CITY OF ALBUQUERQUE

Re: Albuquerque Studio's Bldg 5, 5650 University Blvd SE,
Temporary Certificate of Occupancy (R16-DA3002)
Certification dated 6-12-08

**Re: Temporary C.O. Albuquerque Studios
Building 5
5650 University Blvd. SE Albuquerque, NM 87106**

SITE DEVELOPMENT PLAN

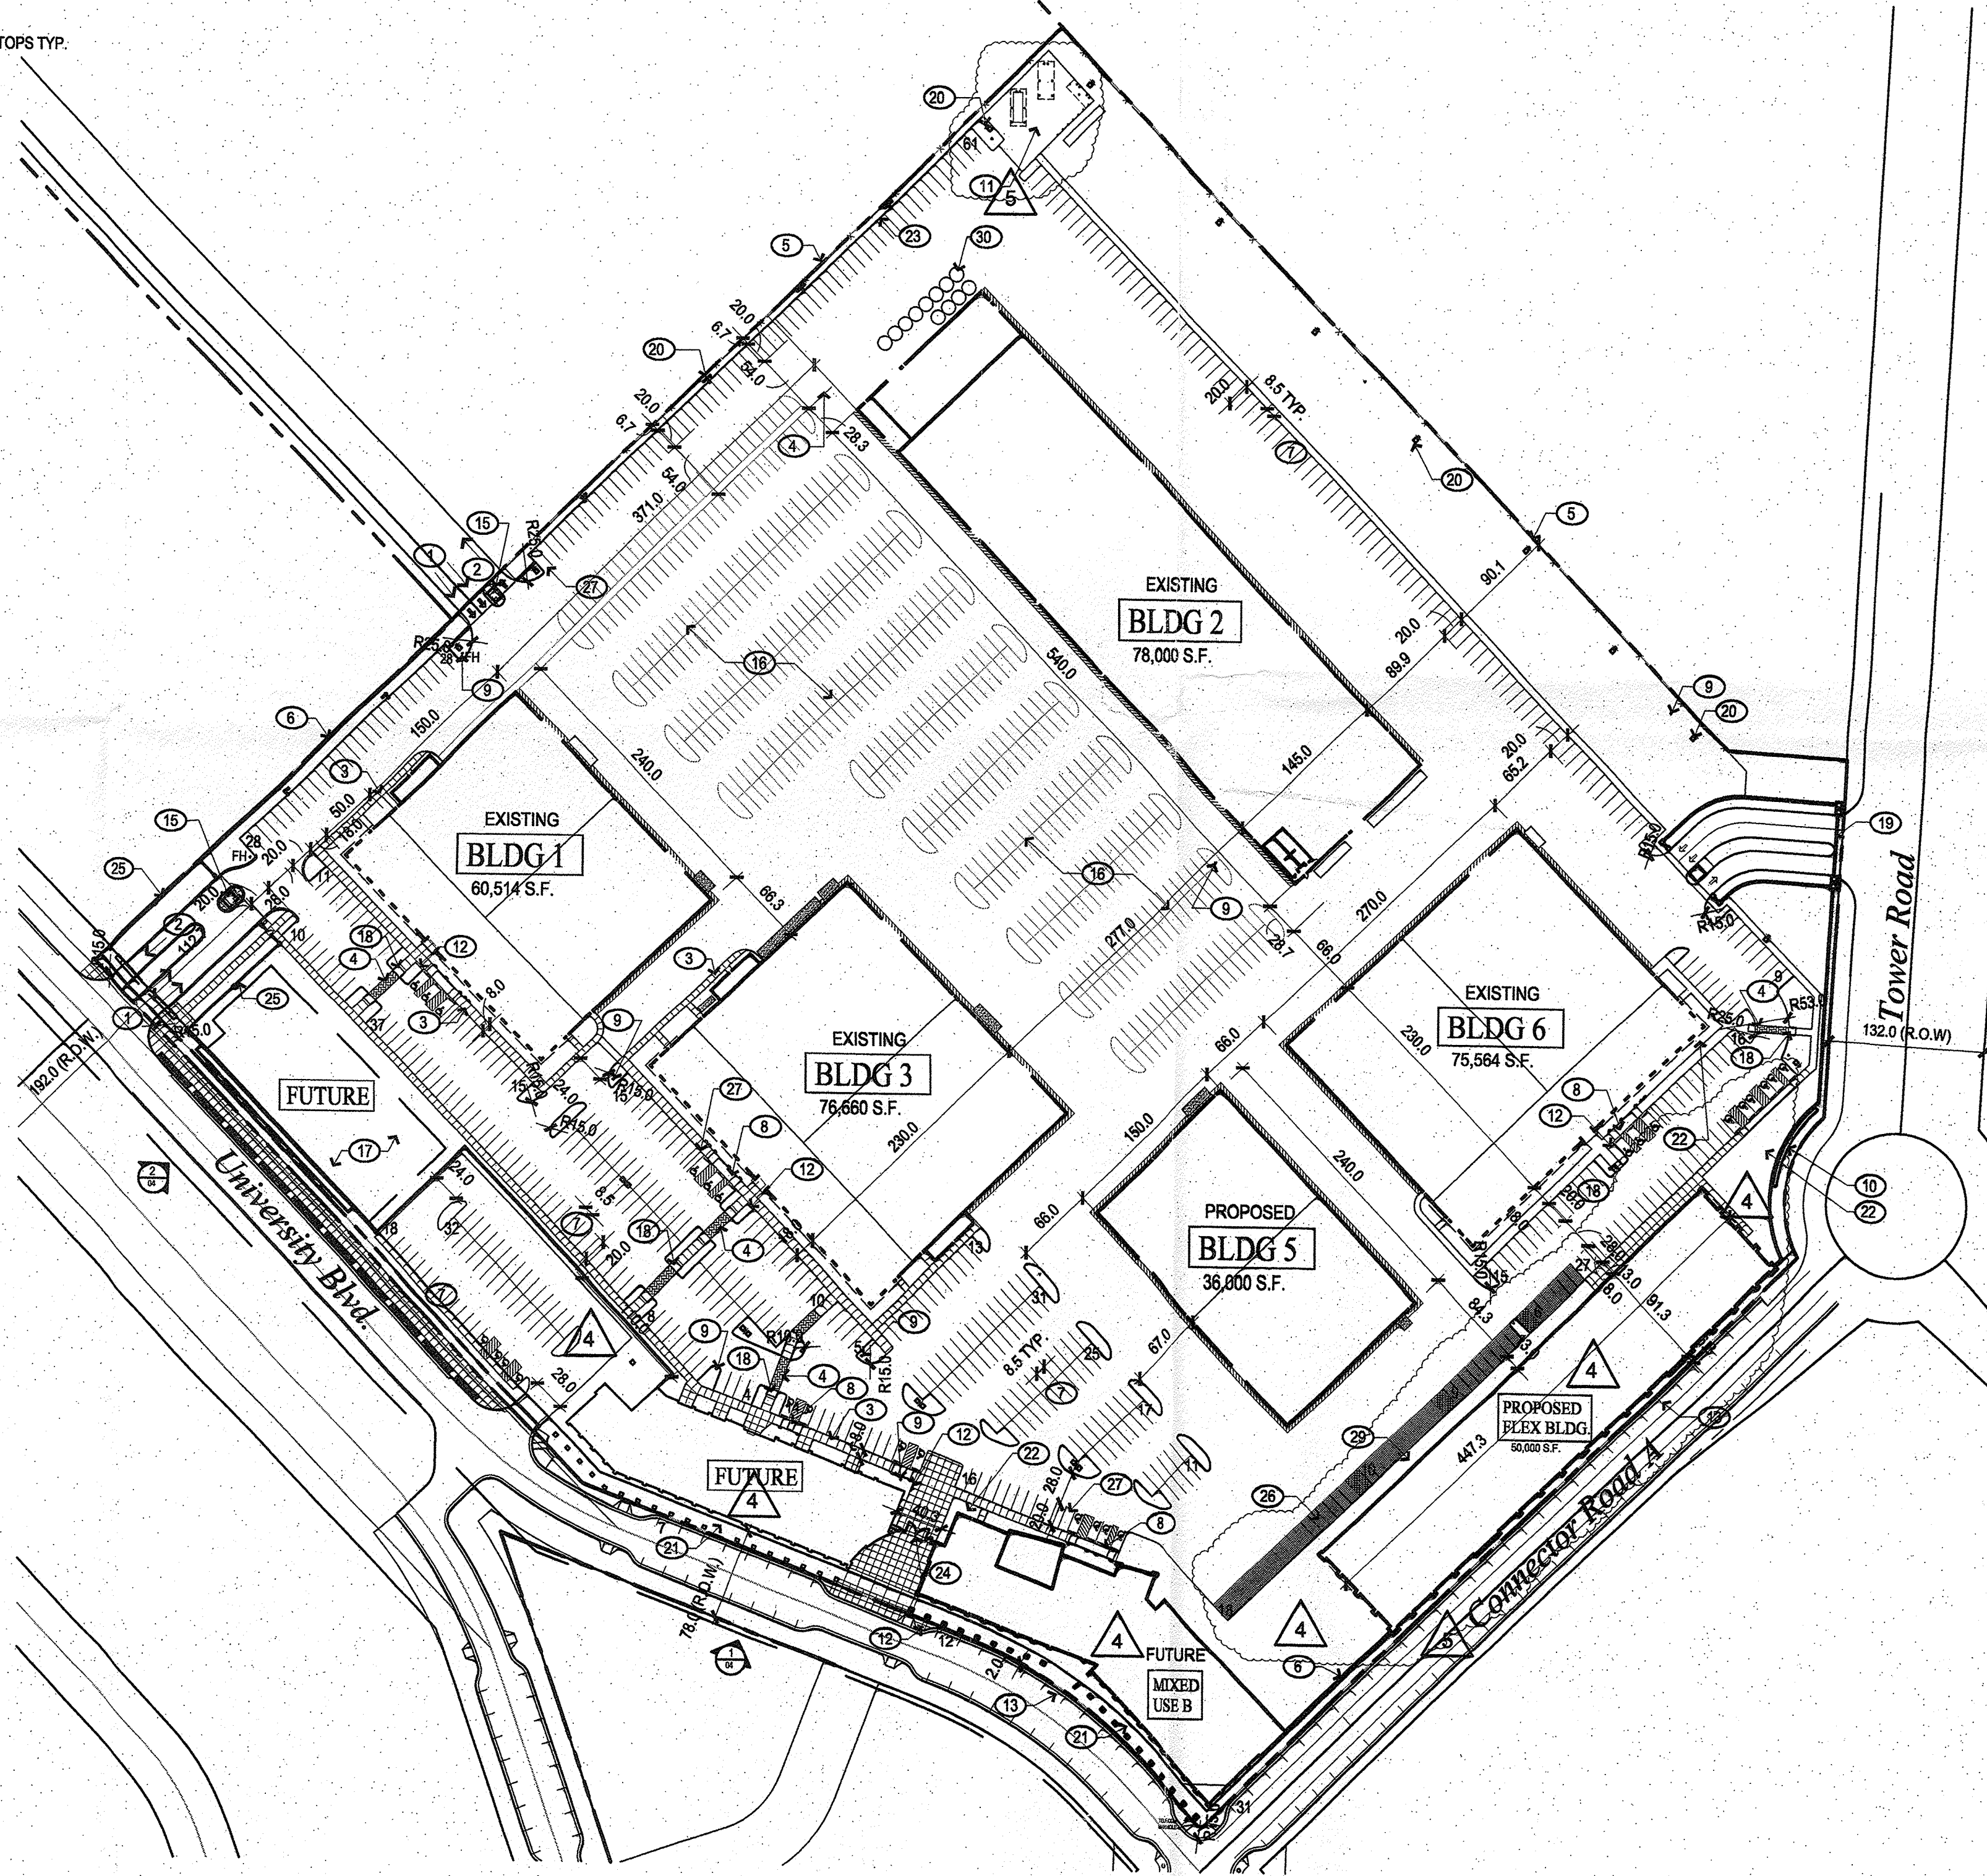
1. Mixed Use Buildings 'A' and 'B' have not been constructed. Due to lack of construction funds these 3 buildings shall not be built at this present time. Because of this fact, the parking area which lines the Mixed Used Buildings on the studios side and several rows of parking to the west of building 5 have not been striped to support these buildings. When these buildings are finally constructed, the parking spaces used to support these buildings shall be striped.
2. Paving along the south side of Building 5 has not been installed due to the construction of the 'Flex' Building located to the south. Paving through this area shall be installed and completed during the construction of the Flex Building. The temporary dirt along the south elevation does not impede the function of Building 5 in anyway; access to all doors is allowable on all sides.

Based upon the information provided in your submittal received 6-12-08, the above referenced certification is approved for release of 30-day temporary Certificate of Occupancy by Transportation Development.
